air pollution control district
SANTA BARBARA COUNTY

**Re: Comments on the 2022 Air Toxics Emission Inventory Plan and Soil Sampling Plan
Santa Maria Regional Landfill
Air Toxics “Hot Spots” Information and Assessment Act (AB 2588)**

Santa Maria Regional Landfill 2022 ATEIP Incompleteness Items

Santa Maria Regional Landfill Soil Moisture and Silt Content Plan Incompleteness Items

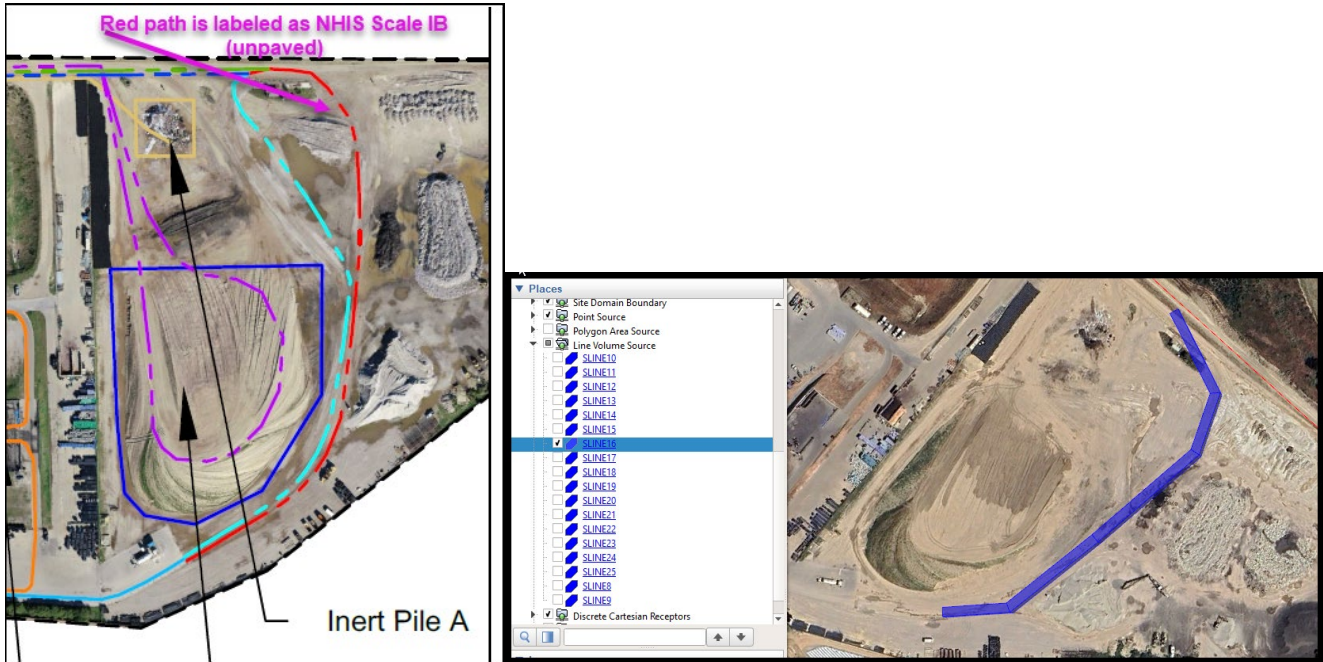
19. Wind Speed for AP-42 13.2.4 Aggregate Handling and Storage Piles. Provide the 2022 meteorological data and location that the mean wind speed of 6.4 mph is based on. If there are other monitoring stations that are closer, justify why the one selected is more representative.
20. Section 4.8.4. The screenshot below shows an incomplete equation (in yellow) from Section 4.8.4 for maximum hourly PM₃₀. This partial equation is not needed because there is also a speciated TAC maximum hourly equation (shown in green). Remove the partial maximum hourly PM₃₀ equation.

The yellow equation isn't needed because the green equation is also shown.

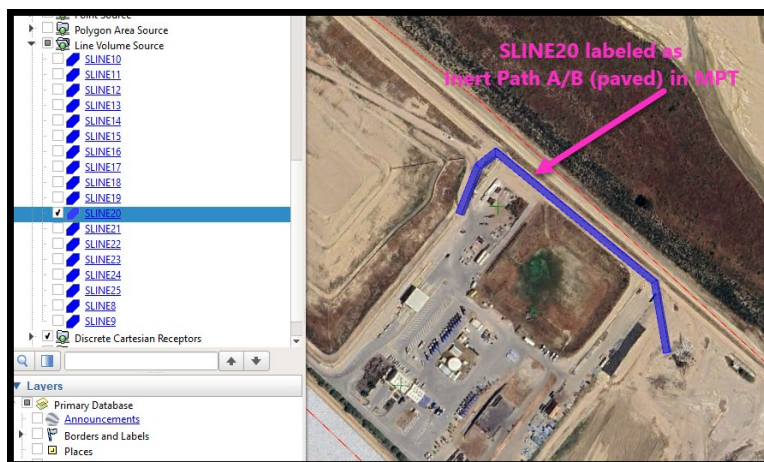
35. Route Names – SLINE16. SLINE16 is labeled as “Inert Path B (unpaved)” on the *Source Parameters* tab of the *Modeling Protocol Tables*. However, this route is labeled as “NHIS Scale IB (unpaved)” on the 2022 *ATEIP Emissions Map*. SLINE 25 is also labeled as Inert Path B (unpaved). Reconcile the names of the routes and line sources; update the *Source Parameters* tab of the *Modeling Protocol Tables* and the 2022 *ATEIP Emissions Map* accordingly.

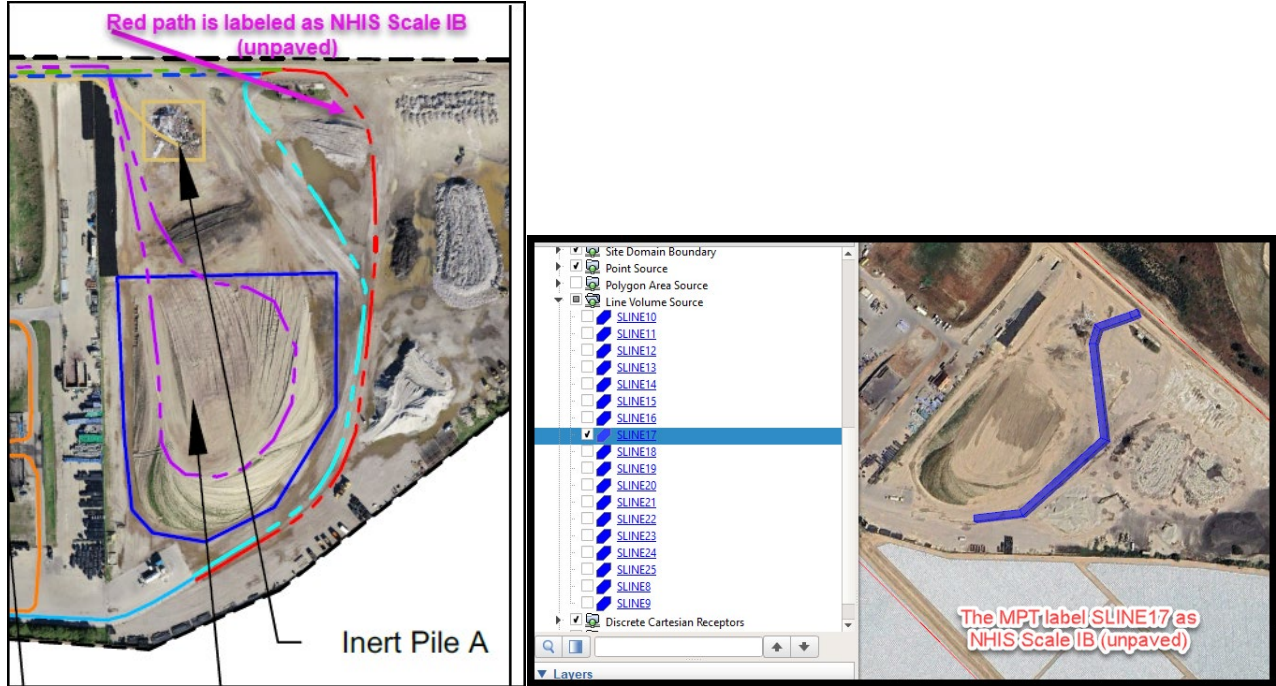
36. Route Names – SLINE20. SLINE20 is labeled as “Inert Path A/B (paved)” on the *Source Parameters* tab of the *Modeling Protocol Tables* (MPT). However, this route does not appear to be paved based on the aerial imagery. It appears that SLINE20 may be the Inert Path A (unpaved). There are no SLINE sources listed as “Inert Path A (unpaved)” in the *Source Parameters* tab of the *Modeling Protocol Tables*. Reconcile the names of the routes and line sources; update the *Source Parameters* tab of the *Modeling Protocol Tables* and the 2022 *ATEIP Emissions Map* accordingly.
